# Groundwater Application Review Summary Form

Application # G- 19390

# PUBLIC INTEREST REVIEW FOR GROUNDWATER APPLICATIONS

**A. GENERAL INFORMATION:** Applicant's Name: Crum Ranch LLC C/O Rob Crum County: Gilliam

## Cross-Section

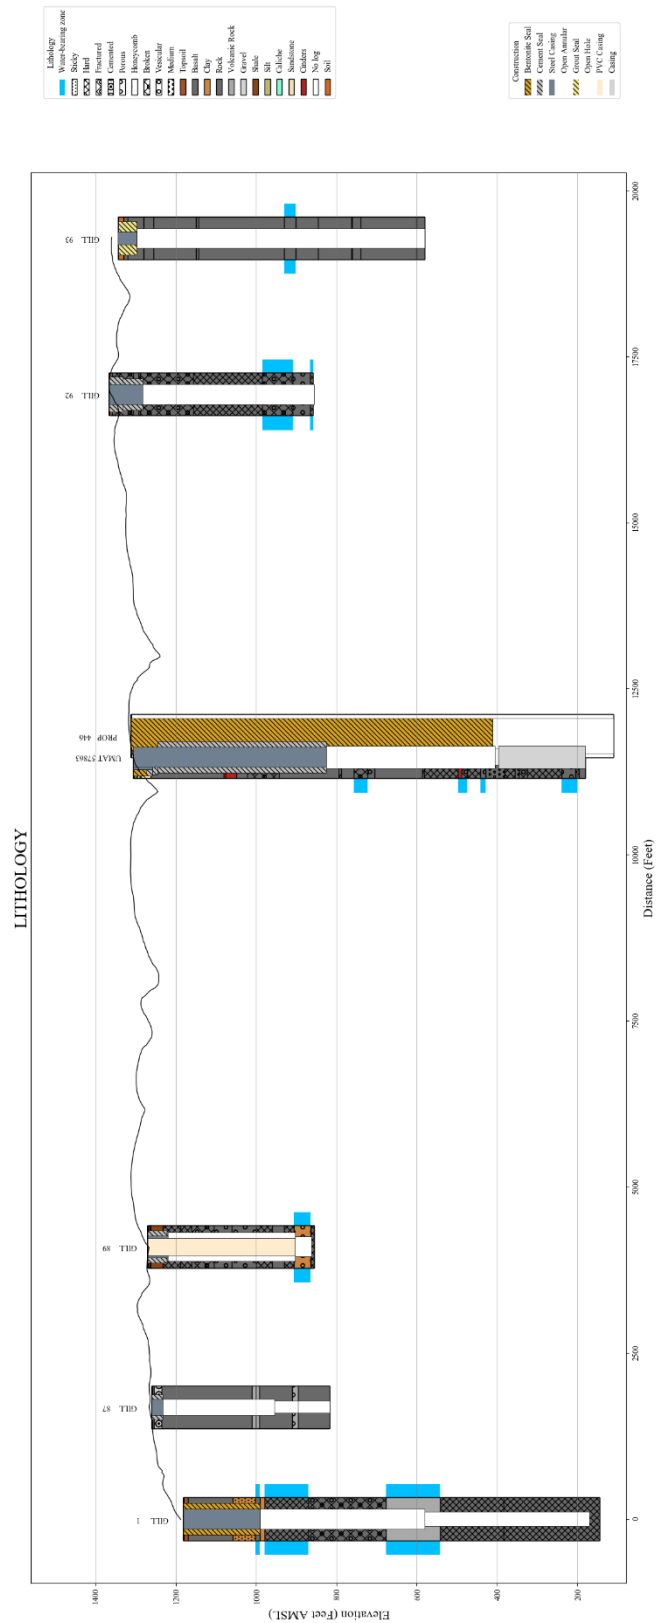
Water levels in the vicinity of the POA have been declining since the mid-1990s (see Observation Well Data). PROP 446 is proposed to be drilled deeper than the wells in the area, however, based on topographic elevation difference, existing well GILL 1 will be open to similar intervals as the proposed POA. GILL 1 has open intervals from approximately 980 feet to 100 feet above mean sea level (amsl), whereas the proposed POA would have an open interval from approximately 420 to 80 feet amsl (See Cross Section below). Water levels in GILL 1 have ranged from approximately 1100 to 1000 feet amsl. GILL-1 is approximately 11000 feet away from the proposed POA.

UMAT 57863, the closest well to the POA, was drilled to 1124 feet bls (183 feet amsl) but then sealed to 908 ft bls (approx. 399 feet amsl) after discussions with OWRD in 2017. A deeper water bearing zone (WBZ) from 1066 to 1104 feet bls (241 -

203 feet amsl) with water level elevation of 304 feet bls (1003 feet amsl) was encountered during the original drilling. The encountered water elevation is similar to GILL 1 water level elevations. This WBZ was sealed off at the time of drilling in 2017 and that is the target zone for the proposed POA in this application. Surficial geologic maps and wells indicate that both UMAT 57863 and GILL 1 are developing Grande Ronde Columbia River Basalt, and the proposed POA would be as well (Swanson et al 1981).

1. Any well authorized as a Point of Appropriation (POA) under this or subsequent permits shall be open to a single aquifer of the Columbia River Basalt Group and shall meet the applicable well construction standards (OAR 690-200 and OAR 690-210). The open interval in each well shall be no greater than 100 feet unless a single aquifer completion can be demonstrated to the satisfaction of the Department Hydrogeologists, using evidence from a video log, a downhole flowmeter, water chemistry and temperature data, or other downhole geophysical methods. These methods shall characterize the nature of the basalt rock and assess whether water is moving in the borehole. Any discernable movement of water within the well bore when the well is not being pumped shall be assumed as evidence of the presence of multiple aquifers in the open interval. Single aquifer completion for any well with an open interval greater than 100 ft should be demonstrated to the satisfaction of the Department Hydrogeologists prior to authorization as a POA under this or subsequent permits.
